# Access Compliance Report

## Public Rights-of-Way

### (Curb Ramps)

Intersection ID: 3572	Main Street: BEECH_CREST_PL	Cross Street: HARRIS_GLEN_DR	Location: NW
ADA ID: AB7F88AD834D	Ramp Type: Perp	Initial Pass/Fail: Fail	Overall Compliance: No
			Severity Score: 21.25

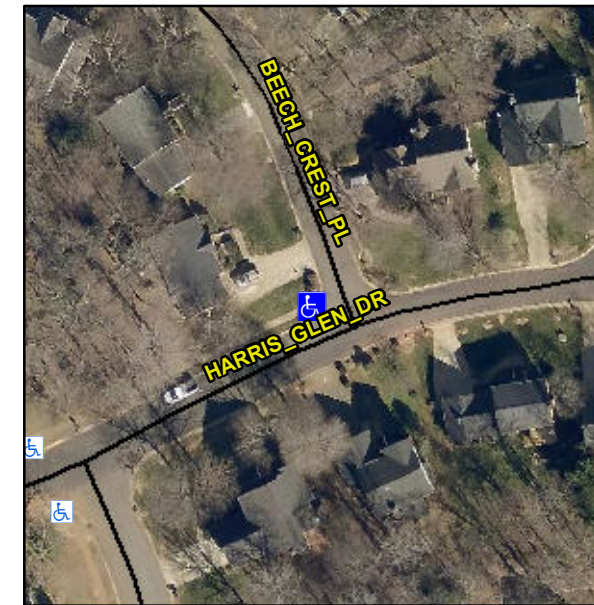
**Not Found, R304.5.1, R304.2.2**

Compliance	Description	Data	Compliance	Description	Data
N/A	Ramp Length (in)	68.0	No	Ramp Slope (%)	11.2
No	Ramp Width (in)	47.5	Yes	Ramp XSlope (%)	1.9
N/A	Flare Type LT	N/A	N/A	Flare Type RT	N/A
N/A	Flare Slope LT (%)	N/A	N/A	Flare Slope RT (%)	N/A
N/A	Flare Traversable LT?	N/A	N/A	Flare Traversable RT?	N/A
N/A	Landing Length (in)	N/A	N/A	DWS Provided?	N/A
N/A	Landing Width (in)	N/A	N/A	DWS Contrast?	N/A
N/A	Landing Slope (%)	N/A	N/A	DWS Length (in)	N/A
N/A	Landing X Slope (%)	N/A	N/A	DWS Full Width?	N/A
N/A	Landing Curb? (Y/N)	N/A	N/A	DWS Offset (in)	N/A
N/A	Shared Landing?	N/A			
N/A	Gutter Ponding?	N/A	N/A	Gutter Slope (%)	N/A
N/A	Gutter Lip Ht (in)	N/A	N/A	Gutter X Slope (%)	N/A
N/A	Painted X Walk1?	No	N/A	Painted X Walk2?	N/A
	X Walk 1 Direction	To E		X Walk 2 Direction	N/A
N/A	X Walk 1 Width (in)	N/A	N/A	X Walk 2 Width (in)	N/A
	X Walk 1 Slope (%)	9.1		X Walk 2 Slope (%)	N/A
	X Walk 1 X Slope (%)	4.1		X Walk 2 X Slope (%)	N/A

**Remove & Replace Entire Ramp.**
